ARCHITECTURAL REVIEW BOARD MEETING

APRIL 25, 2023 IN THE CITY COUNCIL CONFERENCE ROOM AT 5:00 PM

PROJECT NUMBER: SP2023-013
PROJECT NAME: Site Plan for Alkaios Transportation
SITE ADDRESS/LOCATIONS: 1209 N GOLIAD ST

PROJECT NUMBER: SP2023-014
PROJECT NAME: Amended Site Plan for 108 St. Marys
SITE ADDRESS/LOCATIONS: 108 ST MARYS ST

NOTE:
 REFER TO 3/ A502 FOR DUMPSTER ELEVATIONS.

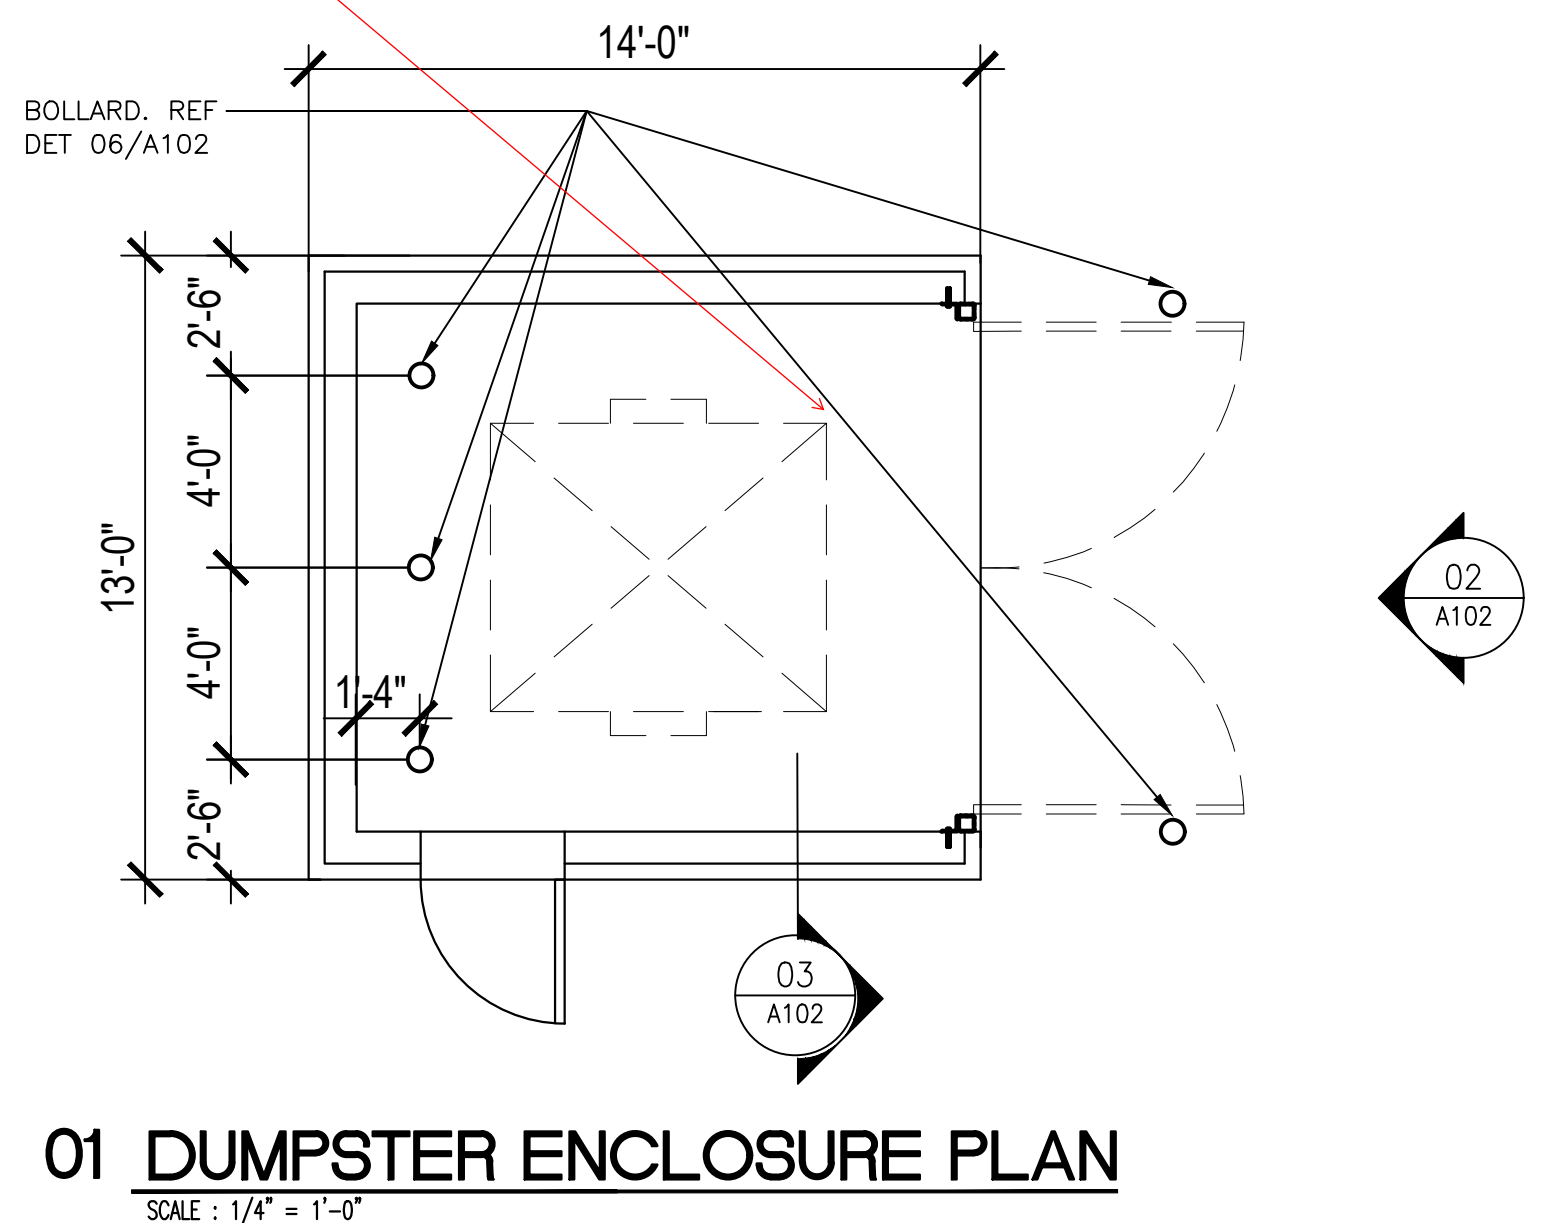
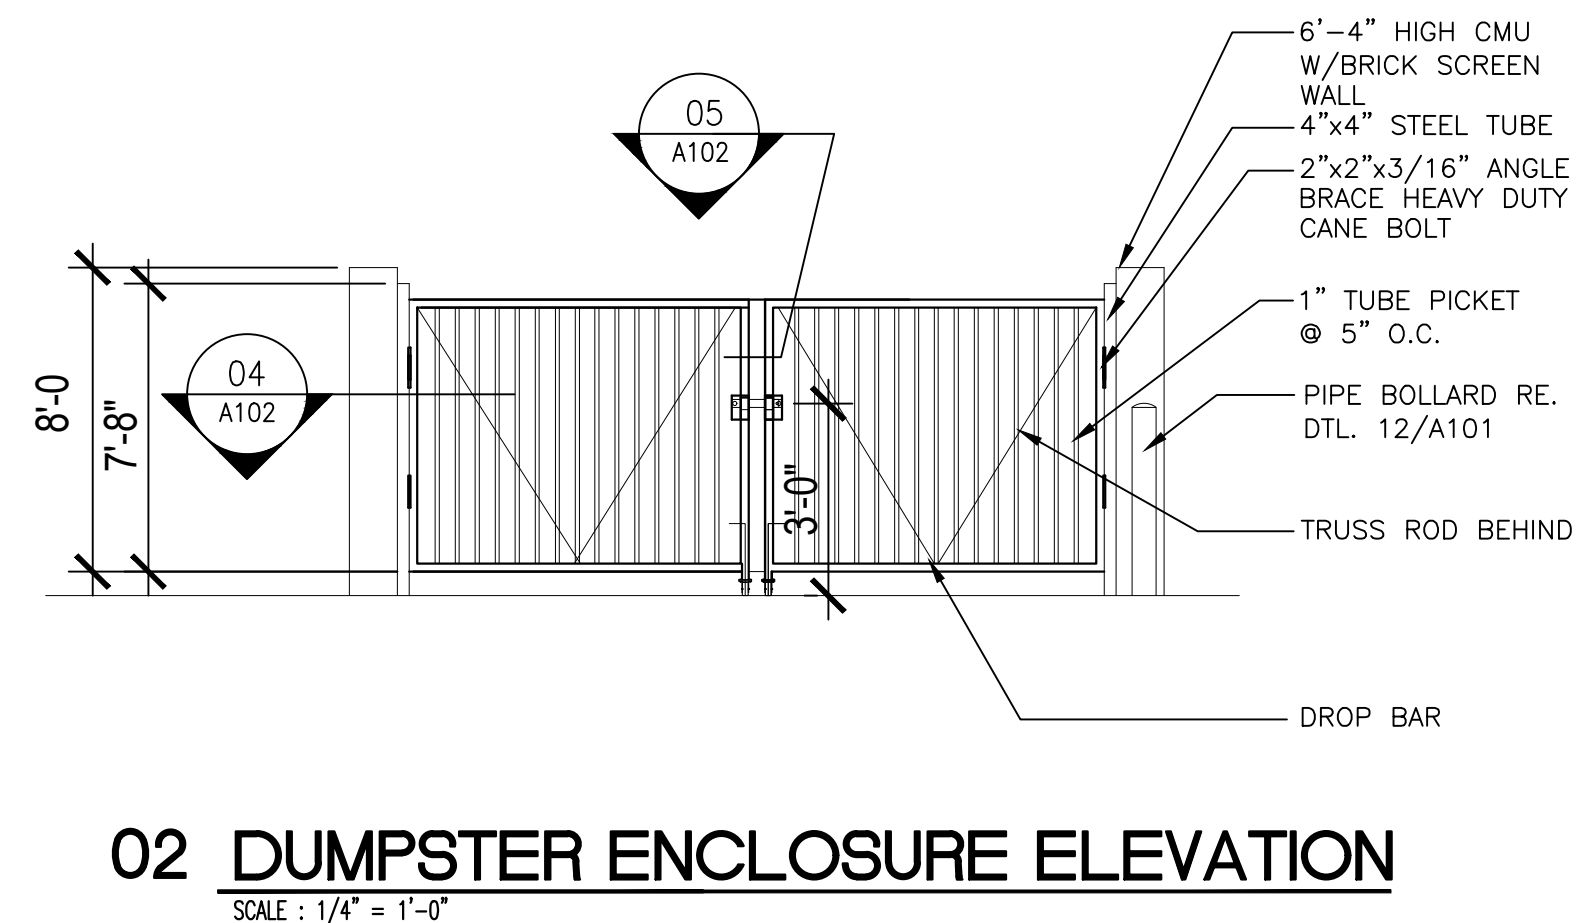
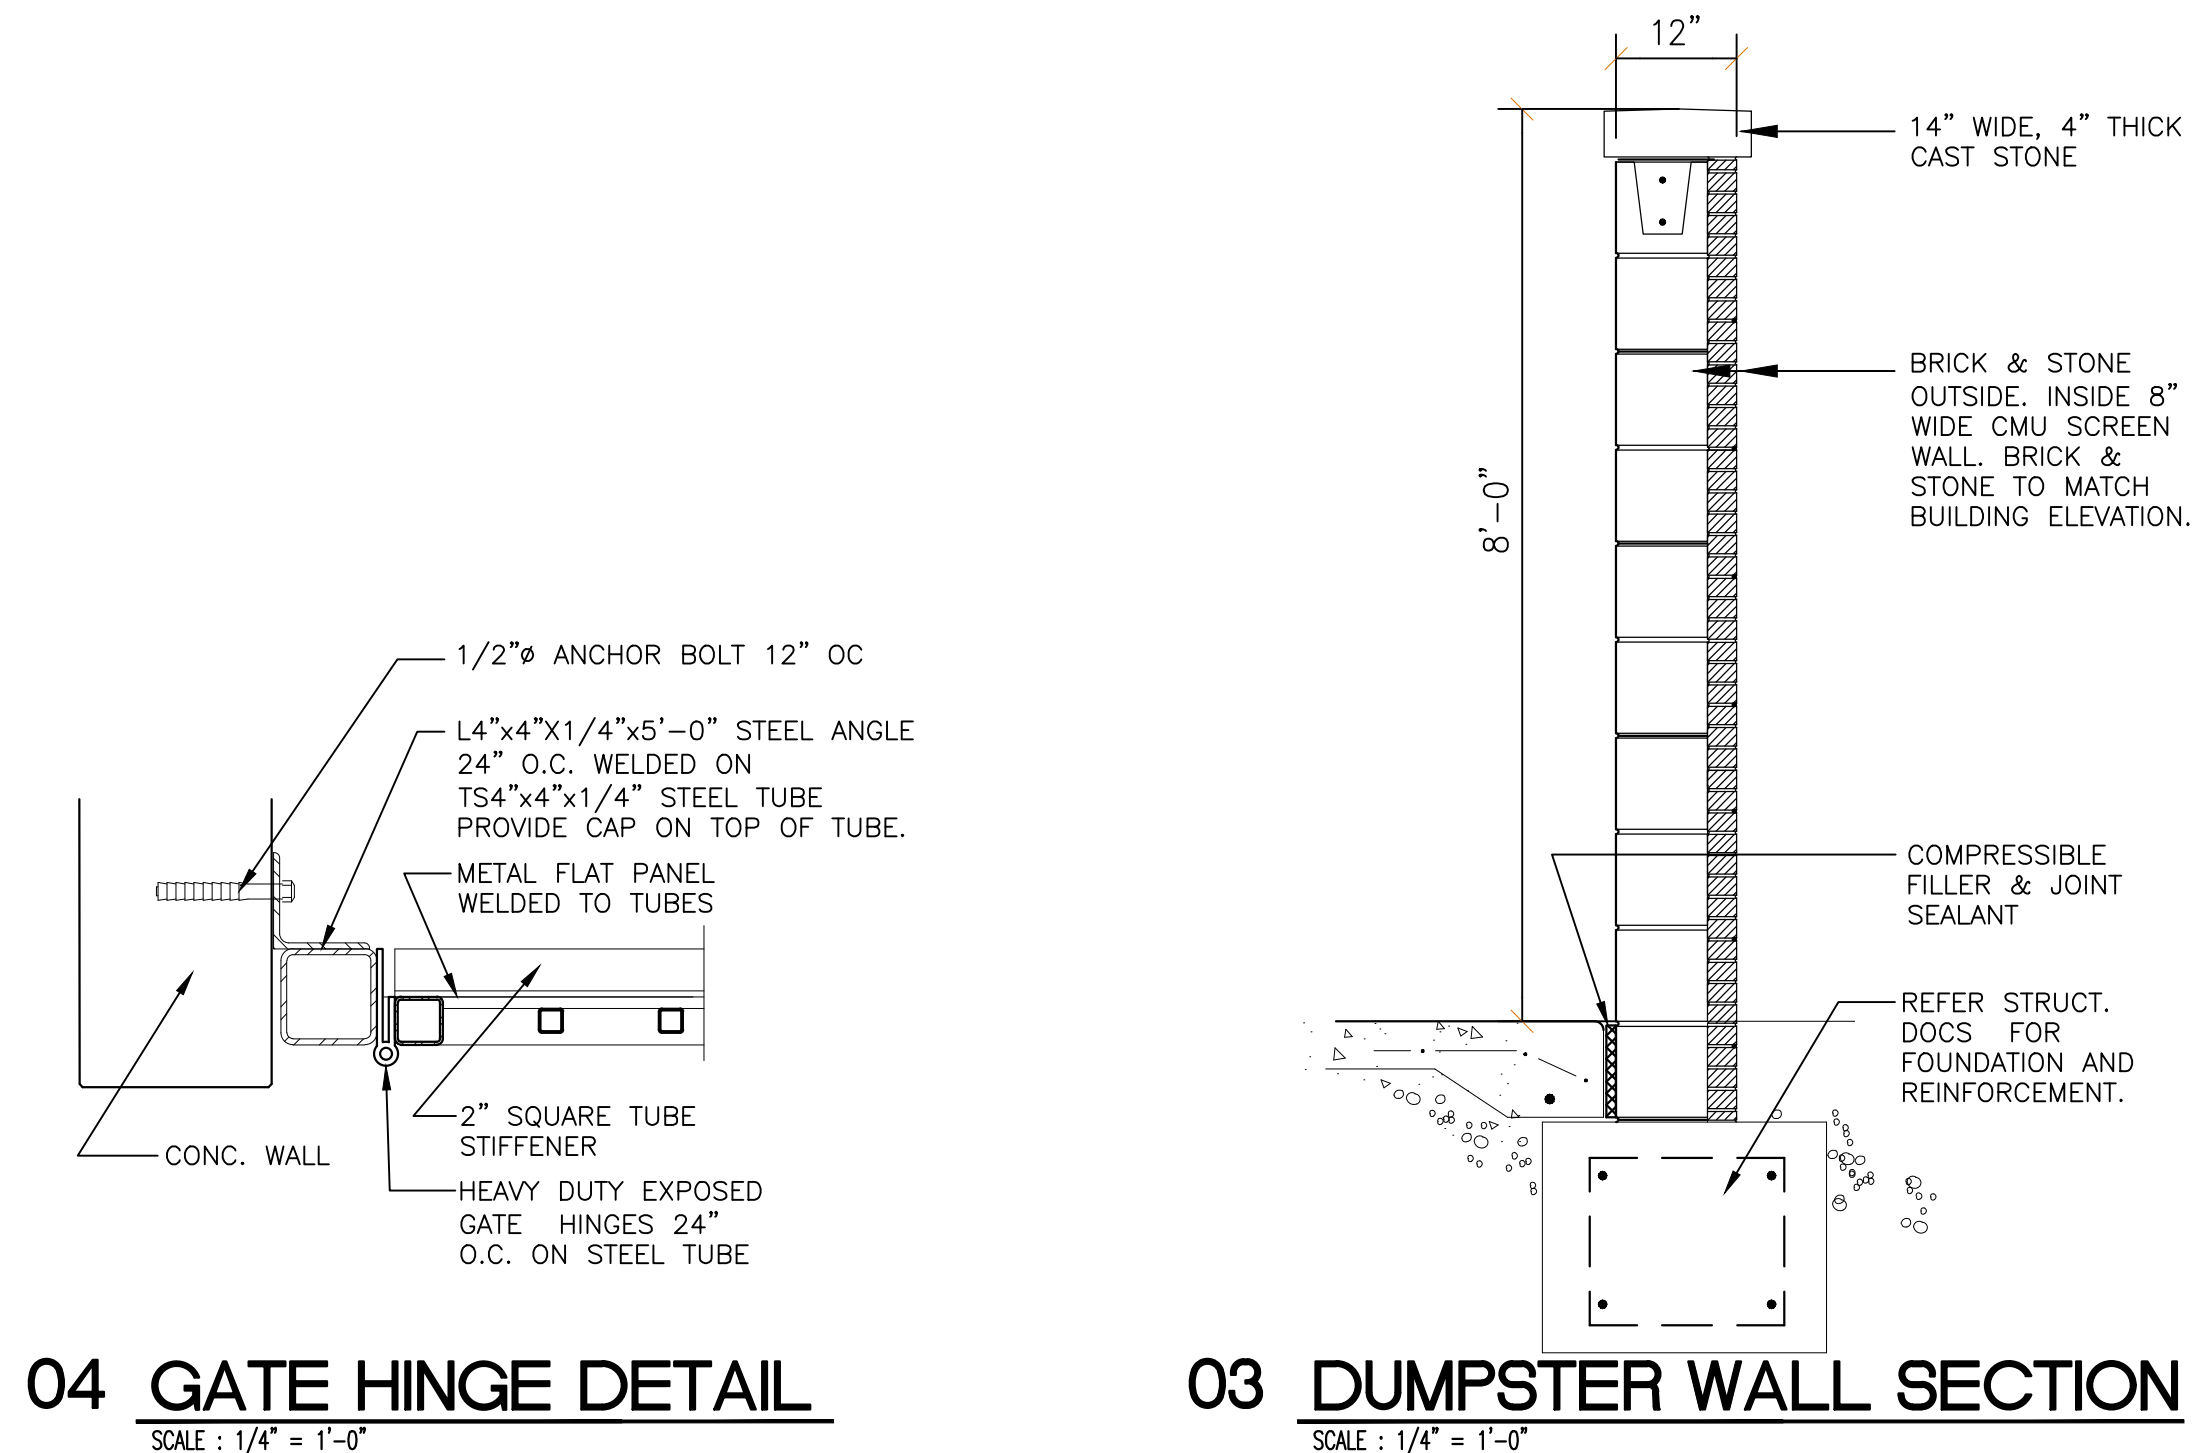
Dumpster area to drain to oil/water separator prior to discharging into storm system
